**PLANNING, ZONING, & BUILDING DEPARTMENT**  
**PZ&B Staff Memorandum: Landmarks Preservation Commission**

SUBJECT: HSB-22-011 (ZON-22-122) 141 AUSTRALIAN AVE (COMBO)

MEETING: MAY 17, 2023

**HSB-22-011 (ZON-22-122) 141 AUSTRALIAN AVE (COMBO).** The applicant, Gregory James Pamel, has filed an application requesting Landmarks Preservation Commission review and approval for proposed exterior alterations to a Historically Significant two-story primary structure, and for the demolition and reconstruction of an existing two-story nonconforming accessory structure in the rear yard, including variances for setback, height, number of stories, and Cubic Content Ratio (CCR). This is a combination project that shall also be reviewed by Town Council as it pertains to zoning relief/approval.

**Sheet 19, Existing South Elevation**

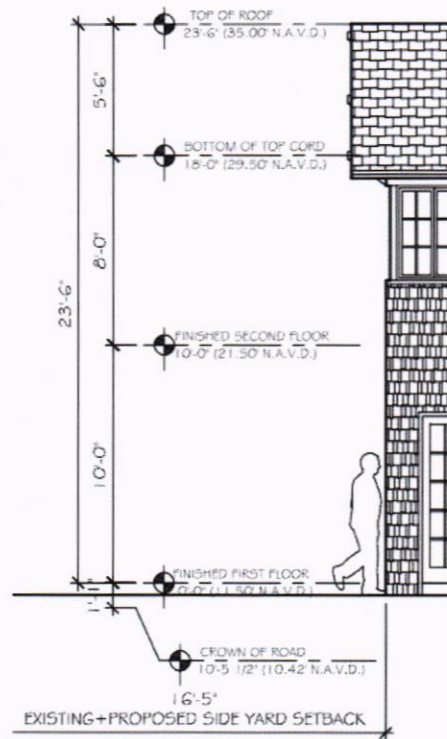
The parcel is located within the FEMA X zone, which is a Non-Special Flood Hazard Area of moderate to low risk. FEMA does not prescribe a finished floor elevation for this zone, but the parcel is relatively high by Palm Beach standards. Per the submitted plans, the building’s finished floor height will be increased with a new foundation from an elevation of 10.96’ NAVD to 11.50’ NAVD. In addition to the increased finished floor elevation, two (2) feet of additional height will be added to the structure’s ground floor walls, resulting in a floor-to-floor height of 10’-0”. The 2.54’ increase in height is most evident in the elevation drawings, provided on Sheets 19-20 of the architectural plan set.

Finished Floor Elevation: 10.96' NAVD  
 Height (From FFE to bottom of top chord): 16'

Finished Floor Elevation: 11.50' NAVD  
 Height (From FFE to bottom of top chord): 18'

Because the applicants are electing to increase the height of the building's finished floor elevation and wall height for a reason other than FEMA compliance, the application will require the same variances initially necessary to reconstruct the building, with modifications to variance amounts. Staff contends that the building could be rehabilitated with a new foundation without increasing the height of the building, and therefore eliminating the need for all five variances.
